TB 190

## TECHNICAL BULLETIN

<b>For the Attention of:</b>	Service Engineers, Installers, Trade Customers, Training Dept.
<b>Date:</b>	12 <sup>th</sup> December 2022
<b>Product:</b>	Stannah Midilift XL+
<b>Subject:</b>	Control unit front panel earth tab

Figure 1

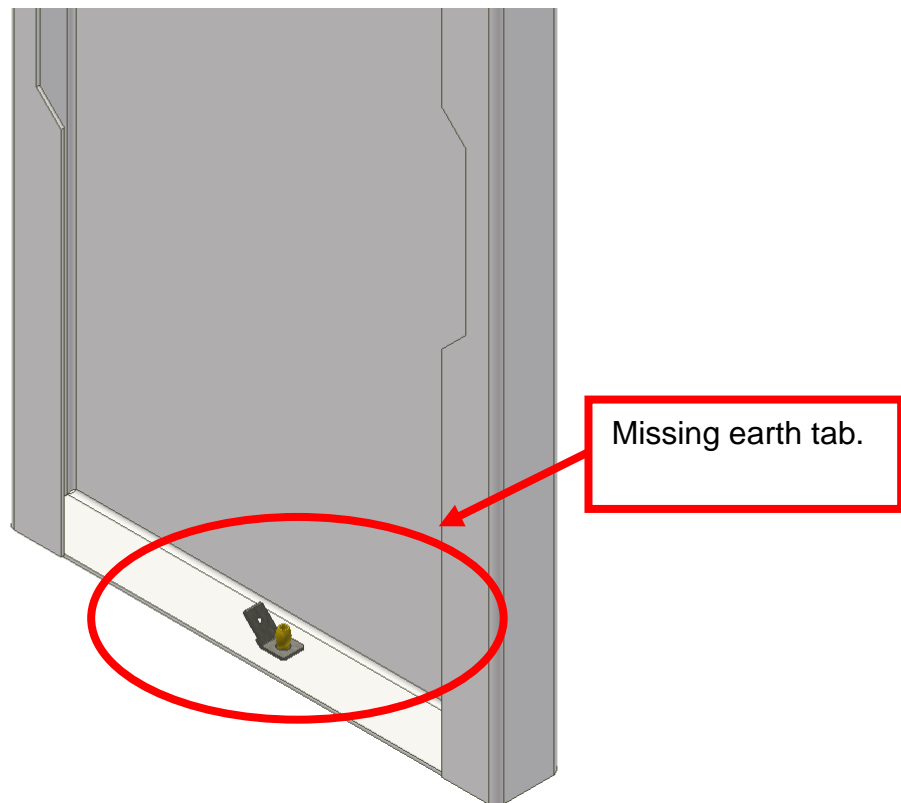
It has become apparent that some XL+ upper landing control unit front panels have been assembled without the earth stud (see Figure 1). If this panel remains unearthed there is an increased risk of an electric shock.

If inspection of the control panel confirms that no earth tab has been fitted an earth tab retrofit kit can be ordered through Stannah lifts spares department under part number 950531.
